2004.07.30 Hw
minor
mod

Re: Minor Modification for re-configuring piping
EPA I.D. No: NYD002014595
DEC Part 373/Air Permit No.3-3340-00027/4-0
Cohoes (C), Albany County

Re: Norlite Corporation
6 NYCRR Part 373 Permit No. 4-0103-16/16-0
6 NYCRR Part 373 Minor Permit Modification-reconfigure piping
for permitted hazardous waste tanks

The following modifications involve changes to the piping of the permitted hazardous waste storage tanks 335-300, 400, 500 & 600 (outside tanks). The revised drawings reflect the following changes:

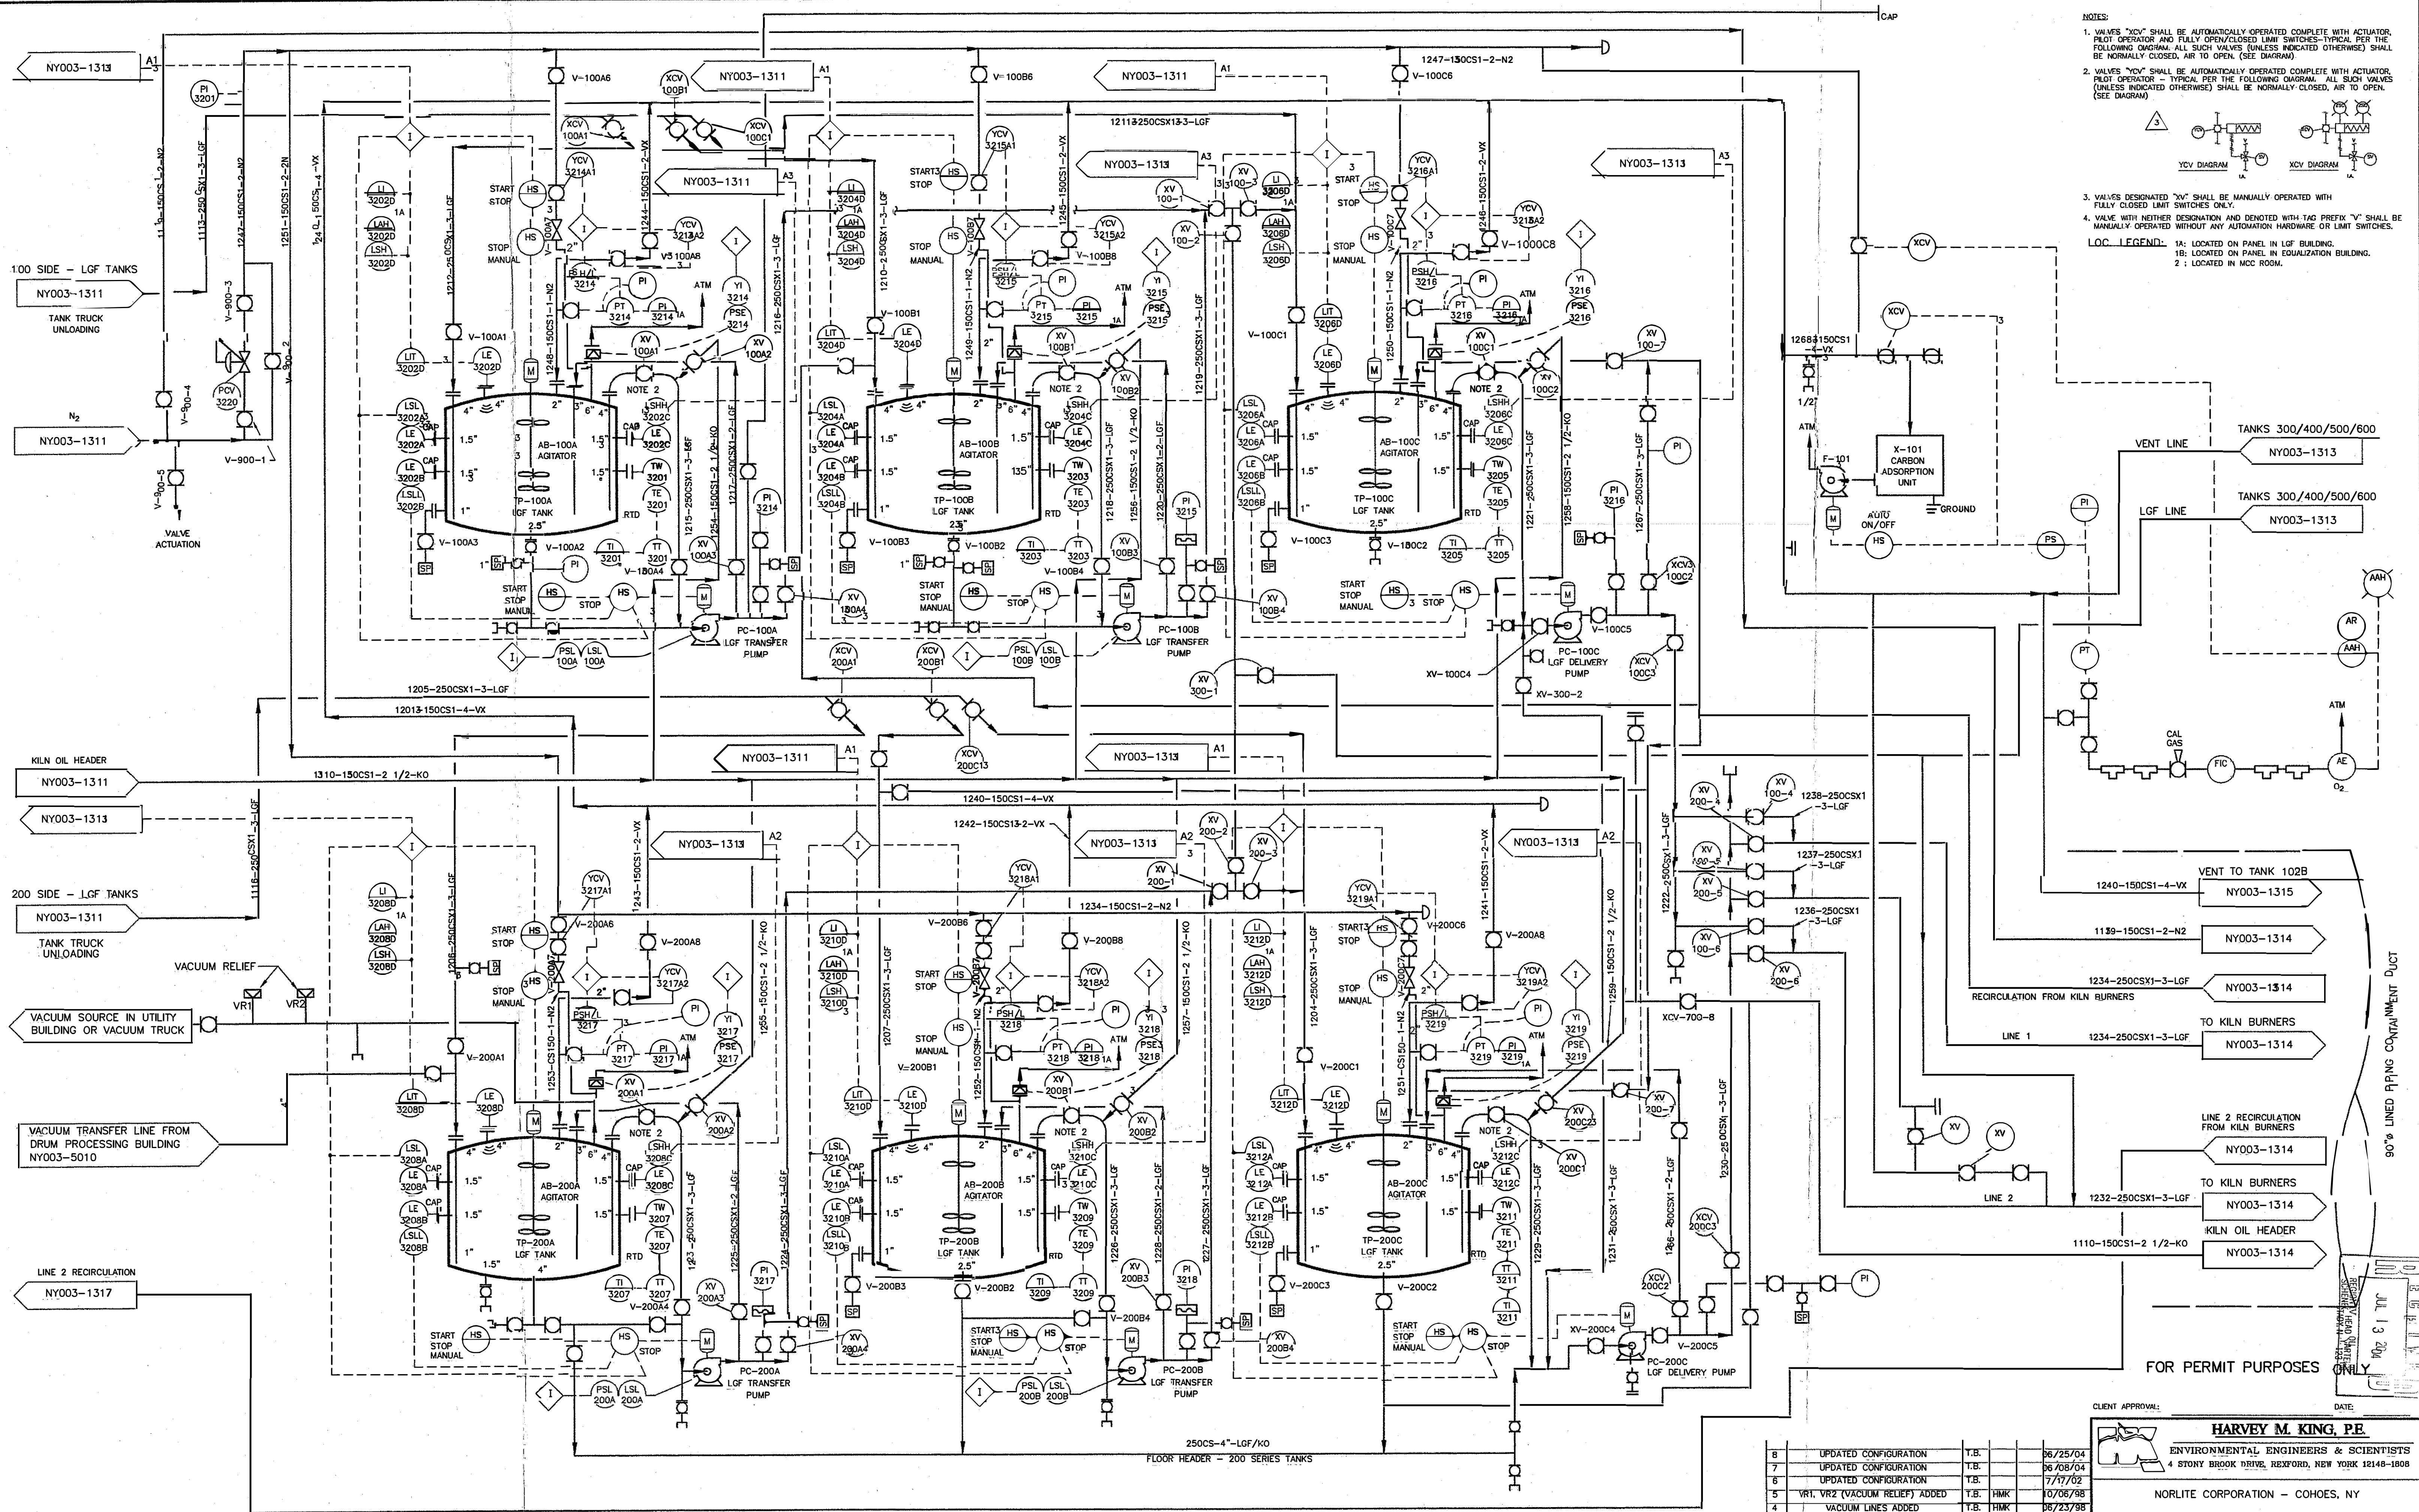
- The installation of new piping, valves and tank nozzles, as well as modifications of existing piping, will facilitate the recirculation of LGF from the kiln burners back to the outside tanks. The recirculation will only occur after the agitators have been installed as per the modification approved on April 20, 2004. These modifications are shown on drawings: NY003-1312, NY003-1314, NY003-1315, NY003-1317, NY003-5432 and NY003-5433.

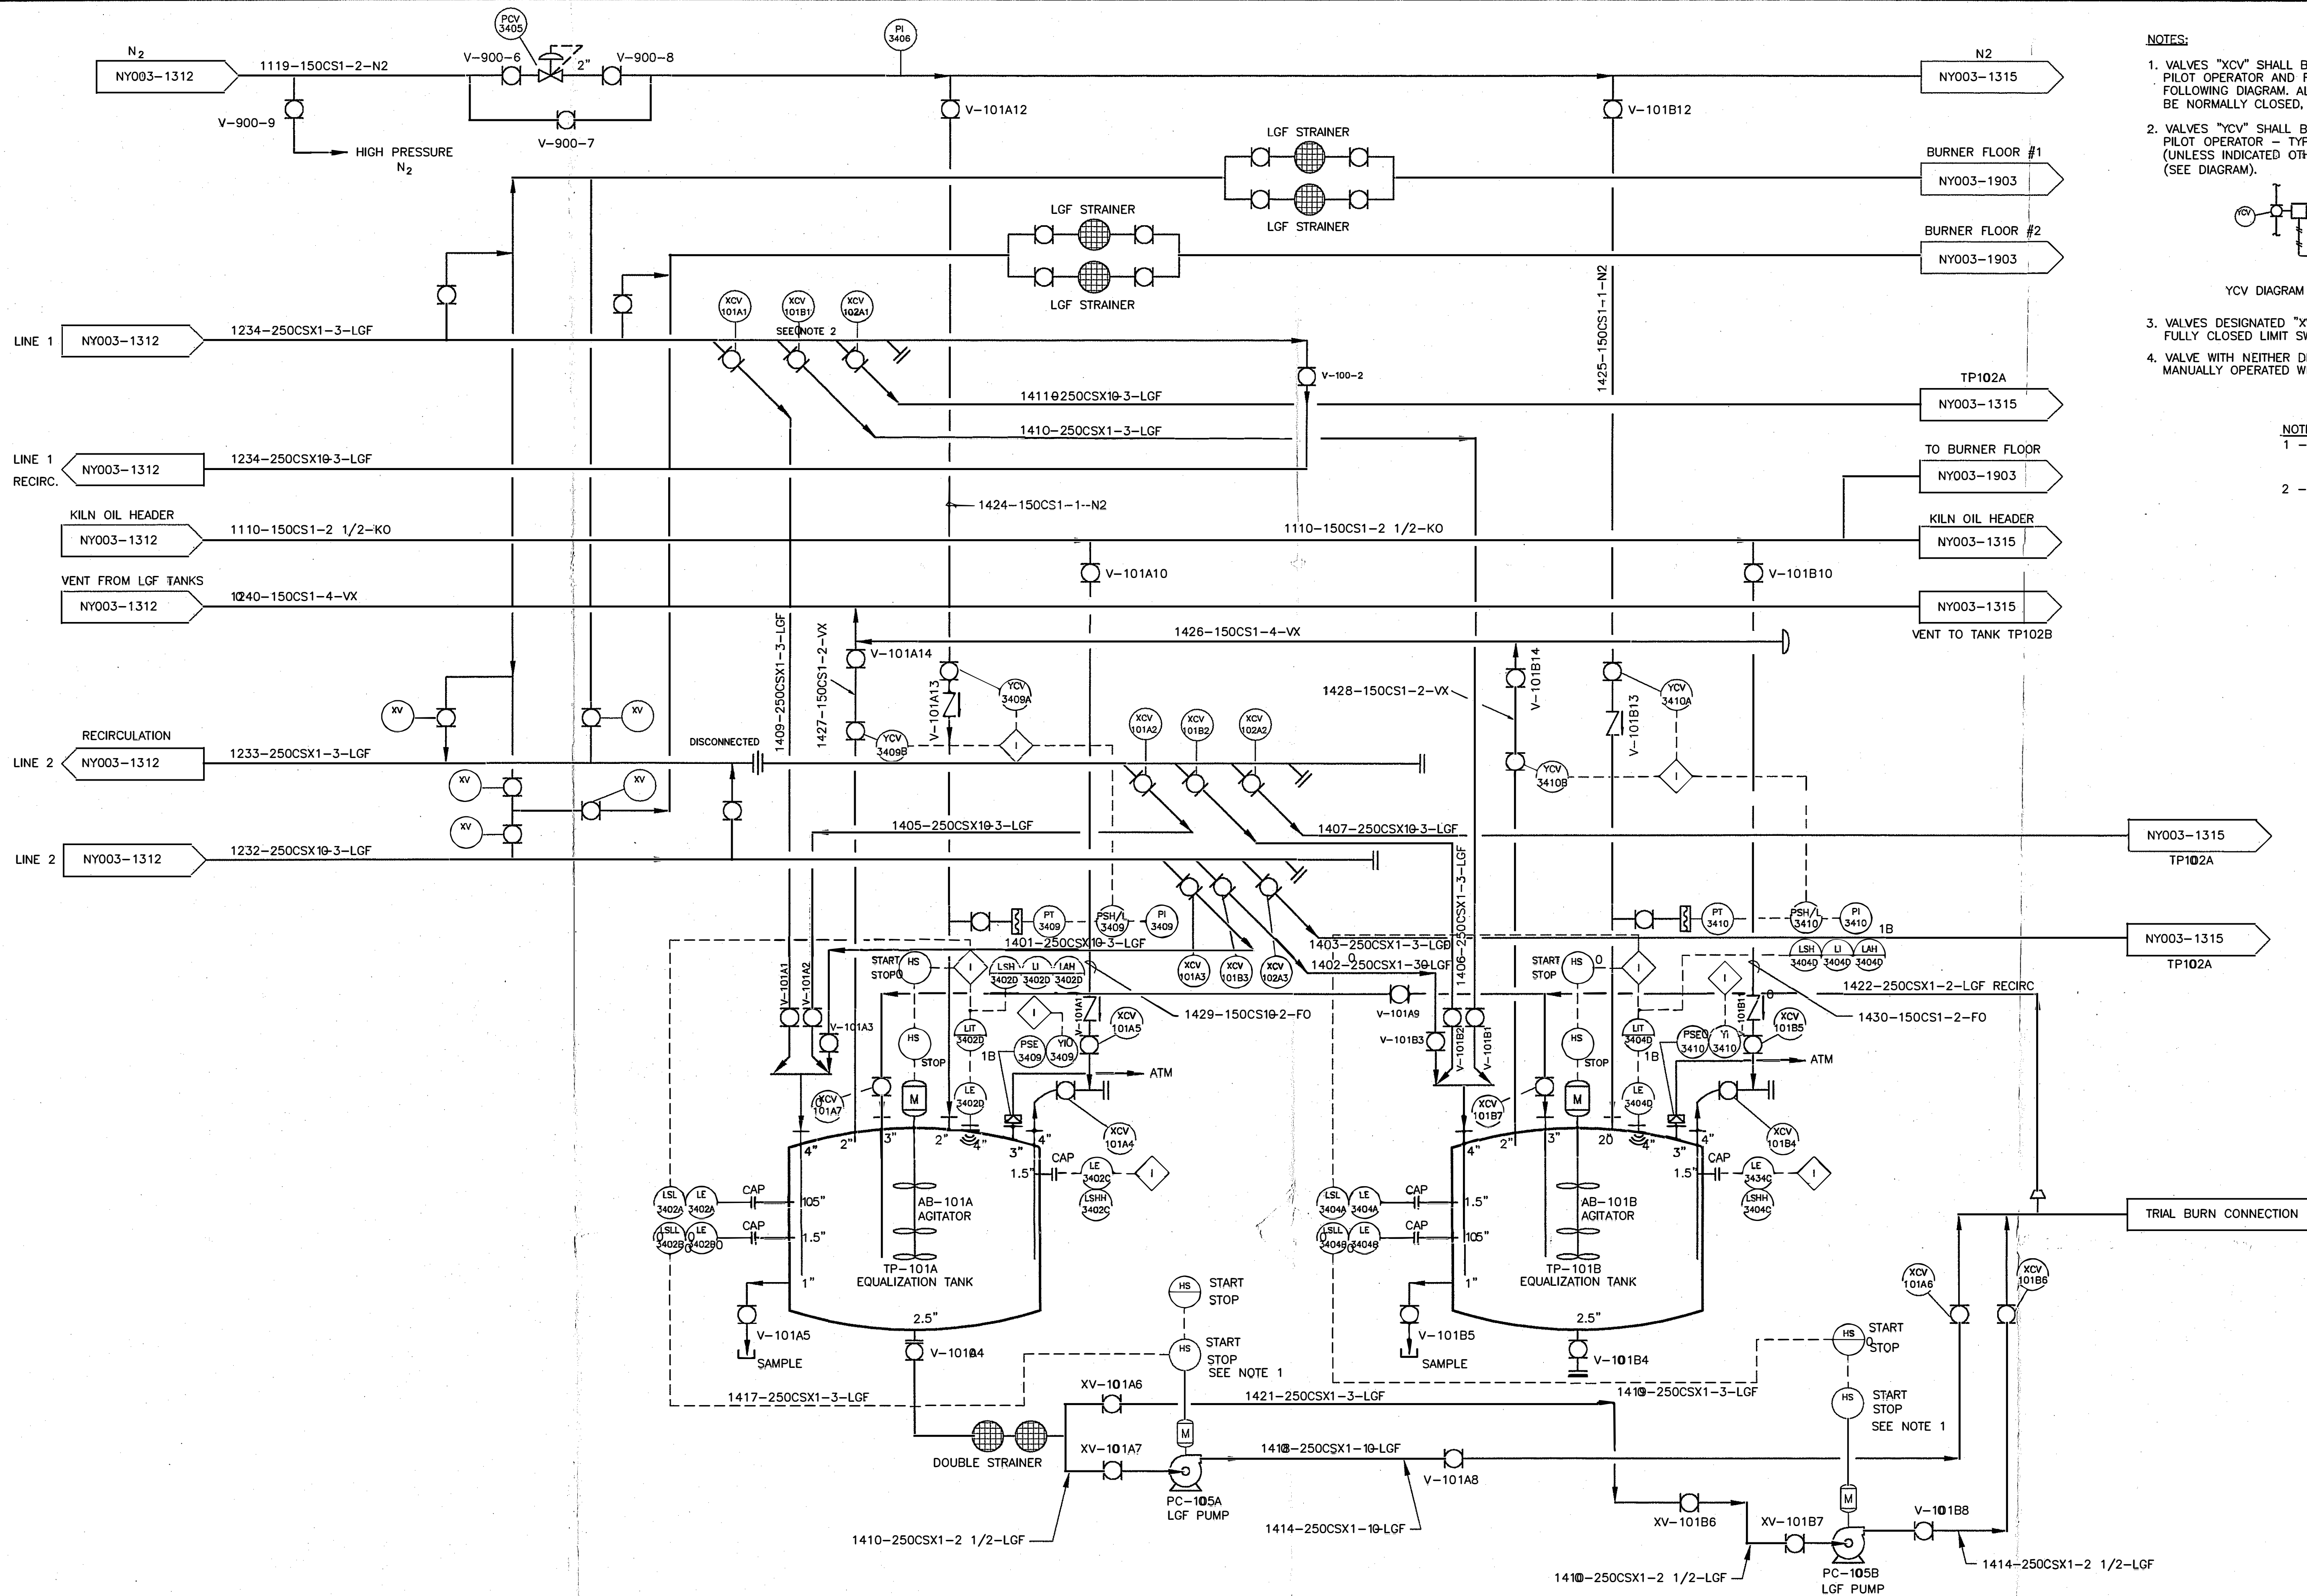
- The installation of a crossover line and valves from line #1 to line #2 in the equalization building will allow Norlite to burn LGF on Kiln #2 from the inside tanks and Kiln #1 from the outside tanks. This modification is shown on drawing NY003-1314.
